10/573,061

Office Action Summary	Application No. 10/573,061	Applicant(s) BEN-HORIN, RAANAN	
	Examiner Denise R. Anderson	Art Unit 1797

DETAILED ACTION

Applicant's Figure 2

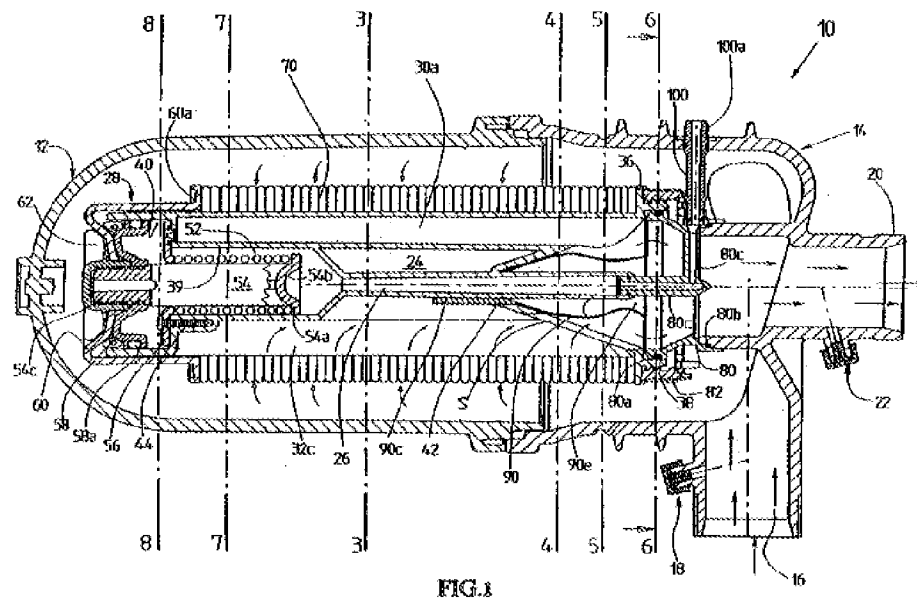
12. The patentability analysis will begin with a comparison of applicant's Figure 2 to that of Sadan et al.'s Figure 1.

structure is analogous to that of Sadan et al. with one difference. Applicant's split ring and seat member are separable and Sadan et al.'s split ring and seat member are integrated, as shown in the figures below. Also shown below is the separable split ring (nut body portion 3 and ring portion 4) and seat member (rim 2 and collar 6) taught by the secondary reference, Clark et al. And finally, a schematic is provided to illustrate the location of the seat member's cone-shaped wall, radial wall, and circular rim, whether the seat member is applicant's or the prior art's.

The new limitation is “to initially force the split ring against the planar radial wall.” This limitation was one which caused claim 1 to be rejected under 112, first paragraph, for new matter, since there was no support for it in the specification, original claims, or drawings. As was stated in that analysis, the examiner is interpreting this limitation to mean that the split ring is located adjacent the planar radial wall as shown in applicant's Figure 2. As such, the figures shown on page 10 of this office action illustrate that both Sadan et al. and Clark et al. disclose the split ring adjacent the radial wall.

Clark et al., Figures 1 and 2

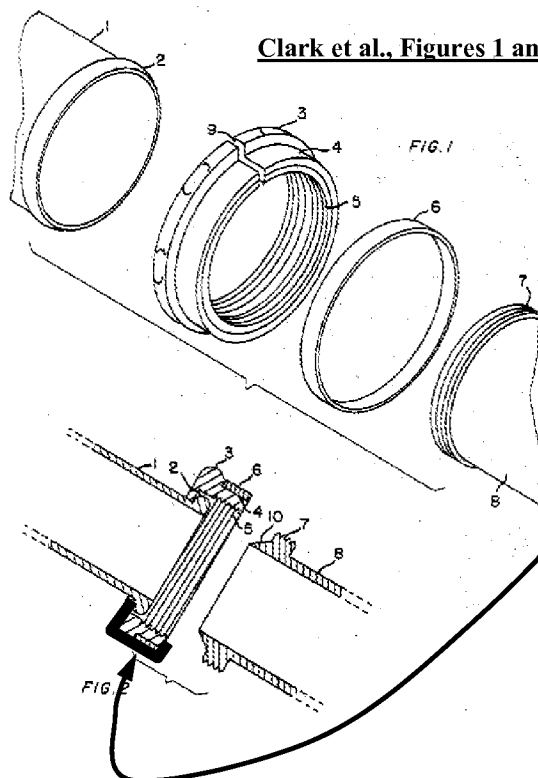
Clark et al. teaches the separable split ring and seat member. It would have been obvious to one having ordinary skill in the art at the time the invention was made to have made the Sadan et al. split ring and seat member separable as taught by Clark et al., since Clark et al. states at Column 1, lines 32-44, that such a modification provides a way to join two pipe-like structures, like the recited inlet port and filter member of claim 1.

Sadan et al., in view of Clark et al., discloses or suggests all claim 3 limitations. In Figure 1, Clark et al. further teaches a stop to avoid the free rotation of the split ring in the form of a “collar 6.” The “collar 6” slides over the “ring portion 4” and is “held there by friction.” “Thereafter, threads 7 and 5 are engaged in the usual manner. Collar 6 now holds the nut [applicant’s split ring] in a fixed circular configuration.” Clark et al., Column 2, lines 23-27. It would have been obvious to one having ordinary skill in the art at the time the invention was made to have included a stop in the Sadan et al. device, as taught by Clark et al., since Clark et al. states at Column 2, lines 26-27 that such a modification would “hold the nut (applicant’s split ring) in a fixed circular configuration,” i.e. avoid the free rotation of the split ring. In summary, Sadan et al., in view of Clark et al., discloses or suggests all claim 4 limitations.

The examiner responds as in the above patentability analysis. Both Clark et al. and Sadan et al. disclose a split ring having an outer surface that is beveled by the same angle as the cone-shaped wall (200b). Because the Sadan et al. split ring is integral with the cone-shaped wall, the angle between the two is the same, as recited. As shown in the figures that appear on page 10 of this office action, Clark et al. discloses a split ring (at nut body 3) with the same angle as the cone-shaped wall (collar 6).
